FACPAC Contract Change Order

Tier 1 Project: Estill Springs Elementary Phase 2 Renovations & Addition - ESSER III
 BG Number: 22-207 District: Estill County (HB678)
 Status: Active Phase: Project Initiation (View Checklist)

Change Order Number 12-3
 Time Extension Required No
 Date Of Change Order 3/24/2023
 Change Order Amount To Date Increase

PR # 11 Underslab Sewer Repairs @ Restroom

MODEL 840/841/842

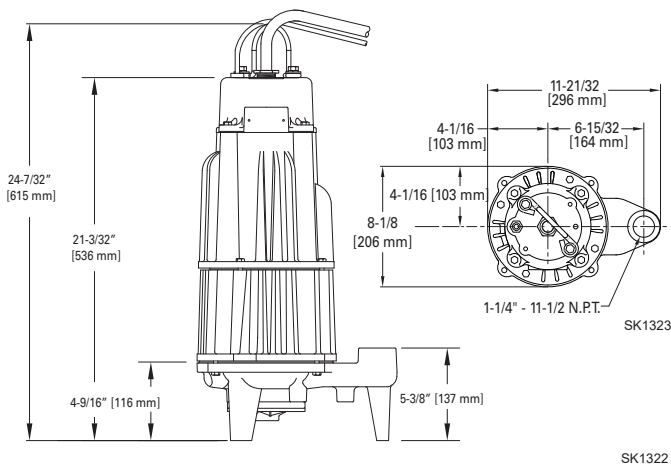
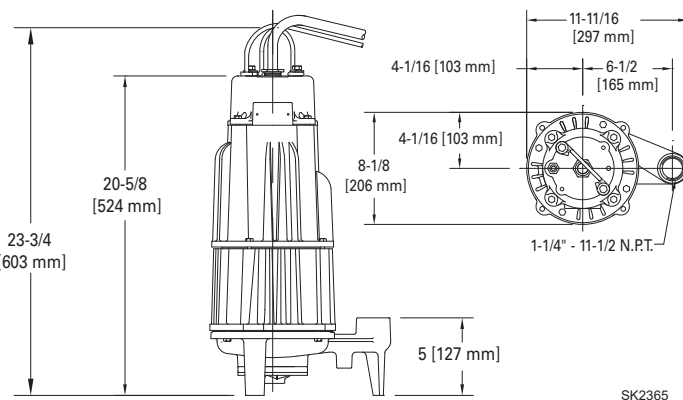
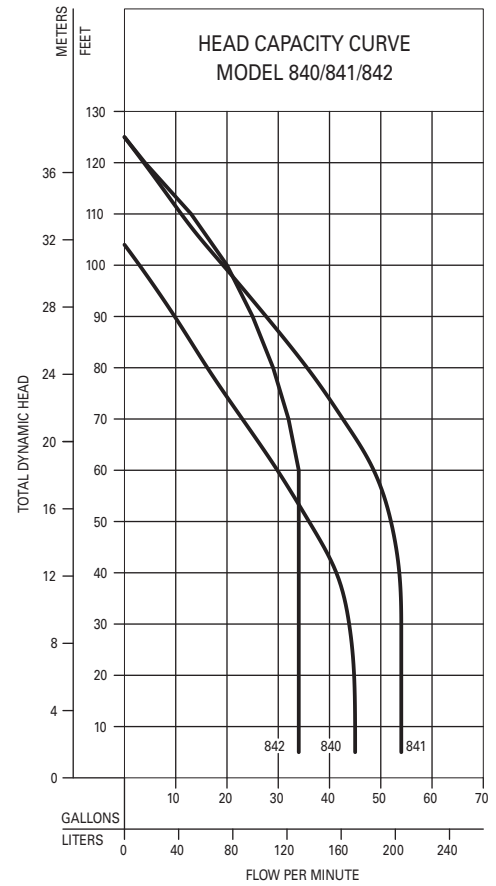
2. Provide pricing to provide and install duplex grinder pump with exterior basin and control panel installed outside the building in the sanitary line downstream of the connection of the two new classrooms. See attached selection: Zoeller Shark Series – Pump Model 840 with 45 GPM at 10' of head. Duplex control panel with NEMA 4X enclosure, audible and visual high water alarms, starting, control, and alarm circuits, circuit breaker and rated motor contactor, alternating circuit, high water alarm light with flasher, HOA switches and pilot lights. 36"W x 60"D Fiberglass outdoor basin with anti-flotation ring, rail disconnect system, inlet and discharge pipe seals, float tree with floats. Route electrical circuit from existing panel in kitchen – field verify panel location and circuit space. Pipe discharge under existing restroom to main in corridor separate from line serving the restroom fixtures. (See attached)

2. Provide pricing to provide and install duplex grinder pump with exterior basin and control panel installed outside the building in the sanitary line downstream of the connection of the two new classrooms. See attached selection: Zoeller Shark Series – Pump Model 840 with 45 GPM at 10' of head. Duplex control panel with NEMA 4X enclosure, audible and visual high water alarms, starting, control, and alarm circuits, circuit breaker and rated motor contactor, alternating circuit, high water alarm light with flasher, HOA switches and pilot lights. 36"W x 60"D Fiberglass outdoor basin with anti-flotation ring, rail disconnect system, inlet and discharge pipe seals, float tree with floats. Route electrical circuit from existing panel in kitchen – field verify panel location and circuit space. Pipe discharge under existing restroom to main in corridor separate from line serving the restroom fixtures. (See attached)
